# SERVICE BULLETIN

**NUMBER:** SB 500-11-002, REV A  
**MODEL:** ECLIPSE EA500  
**SUBJECT:** PLACARD INSPECTION AND REPLACEMENT

Figure 1

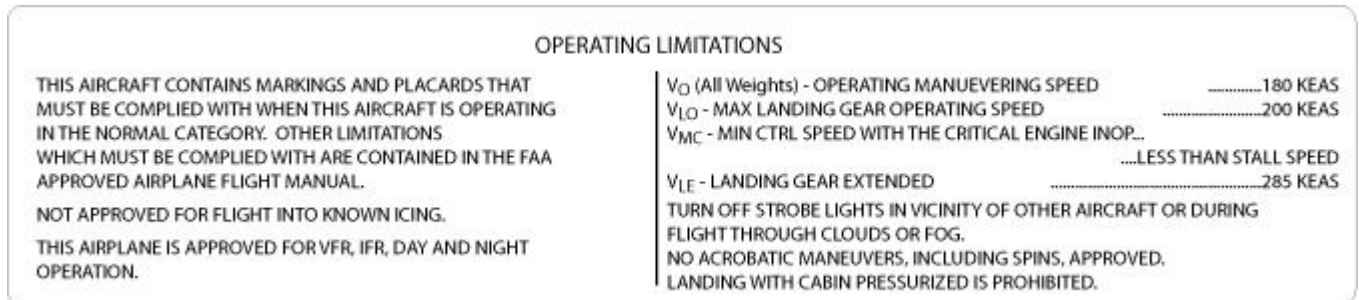
*OPERATING LIMITATIONS* placard may be incorrect. Placard must state NOT APPROVED FOR FLIGHT INTO KNOWN ICING.

- (1) Make aircraft safe for maintenance. Refer to AMM 20-00-01 MAKE SAFE FOR MAINTENANCE.
- (2) Verify placard AIRSPEED/OPERATIONAL LIMITS P/N 11-121963-200X (Figure. 1) is installed in cockpit. Placards are located on left and right cockpit sidewall panels. Refer to AMM 11-30-11 INTERIOR PLACARDS, COCKPIT-INSTALLATION, and IPC 11-30-11 COCKPIT PLACARDS.

NOTE: Placard must state **NOT APPROVED FOR FLIGHT INTO KNOWN ICING.**

- (3) If correct placards are installed no further action is required. If the incorrect placards are installed proceed to step (4).
- (4) Remove incorrect placards. Refer to AMM 11-30-11 INTERIOR PLACARDS, COCKPIT-REMOVAL.
- (5) Install new AIRSPEED/OPERATIONAL LIMITS placard P/N 11-121963-200X in two locations on cockpit sidewall panels. Refer to AMM 11-30-11 INTERIOR PLACARDS, COCKPIT-INSTALLATION, and IPC 11-30-11 COCKPIT PLACARDS.

NOTE: Placards are interior color specific see materials list for part numbers.
